## REVISION TRANSMITTAL

This sheet transmits Revision 2 to SB700-32-01 which:

LANDING GEAR - INSTALLATION OF THE NOSE LANDING GEAR TRUNNION SUPPORT ASSEMBLY  
SERIAL PLACARDS

SB700-32-01  
Page 1 of 4

Figure 1. Placard Installation (Sheet 1)

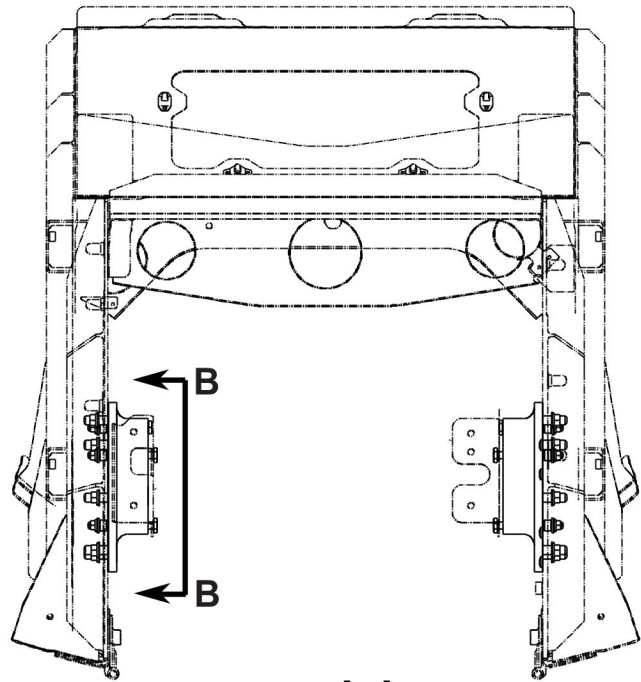
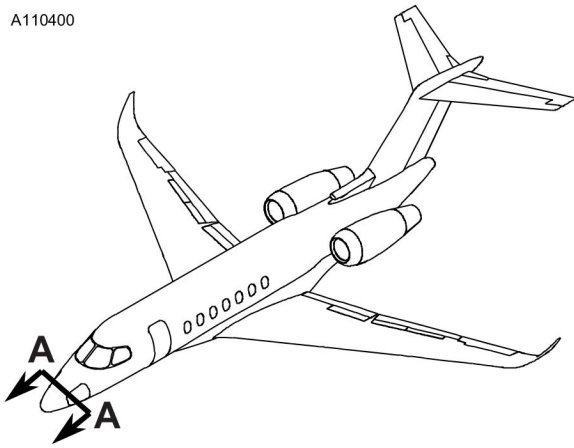
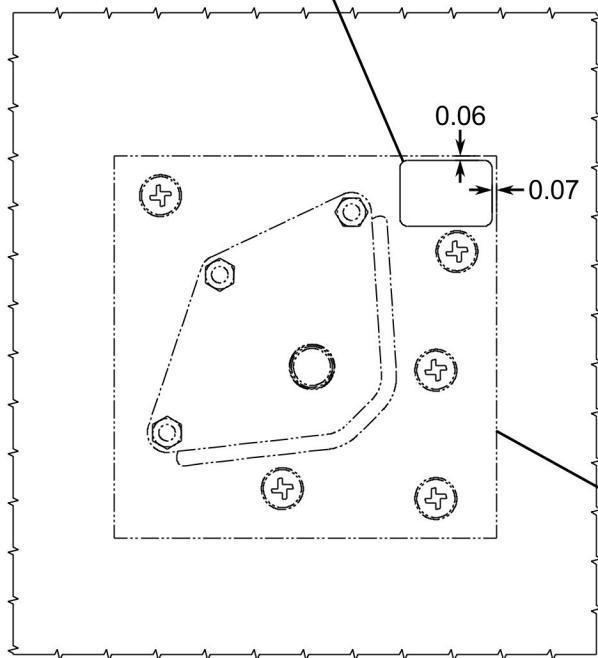
To install missing serial placards on the left and right nose landing gear support assemblies.

This service document provides parts and instructions to install the left and right nose landing gear trunnion support serial placards.

1. Prepare the airplane for maintenance.
  - A. Make sure that the airplane is electrically grounded.
  - B. Make sure that all switches are in the OFF/NORM position.
2. Use a steel stamp to identify the S4515-4 Placard as follows:
  - A. The aircraft serial number in the serial number block.
  - B. 7413215-3 in the part number block for the left side.
  - C. 7413215-4 in the part number block for the right side.
3. (Refer to Figure 1, Sheet 1.) Install the S4515-4 Placards on the 7413215 Trunnion Support Assemblies with U470637, Type I, Class B Adhesive. (Refer to the Citation Standard Practices Manual, Chapter 20, Adhesive and Solvent Bonding - Maintenance Practices.)
4. Apply a top coat of clear polyurethane paint over the placard.
5. Make an entry in the airplane logbook that states compliance and method of compliance with this service document.
